UNITED STATES PATENT AND TRADEMARK OFFICE

09/655,191

Office Action Summary

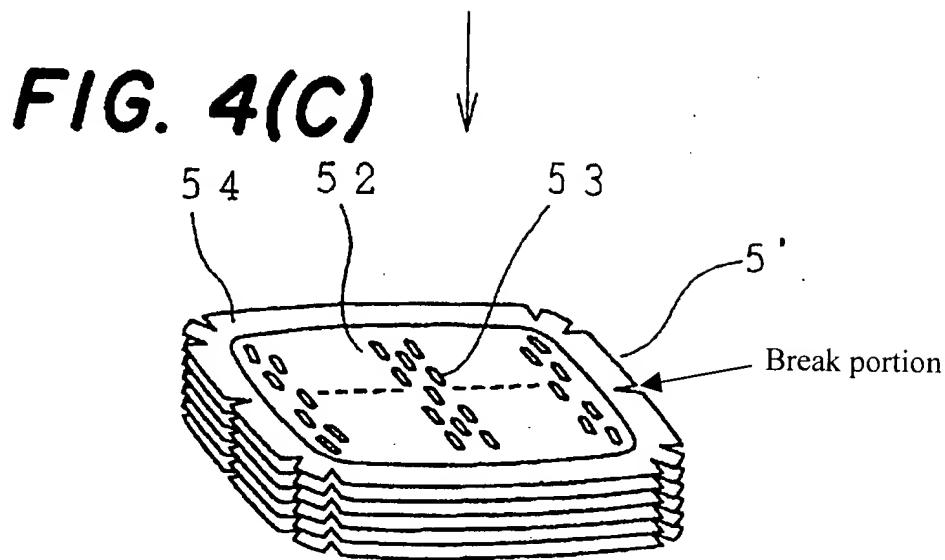
16. In regards to claims 1 and 5, Hosotani discloses in figures 4a-4d, a shadow mask formed from a plate member comprising an outer frame portion (1), a body portion of a shadow mask having an outer peripheral line (54) which is patterned by means of photography (column 2 lines 23-25). Hosotani further discloses a break portion (see below) which is recessed inward from the outer peripheral line of the shadow mask.

28. Hosotani further teaches in figure 4c that the portion to be broken is arranged so as to be opposed to the connection portion. Hosotani further teaches the portion to be broken has a predetermined length in a direction along the outer peripheral line. Hosotani further teaches in figure 4c that the portion to be broken is a portion forming a break portion of the shadow mask from which the outer frame portion is removed.
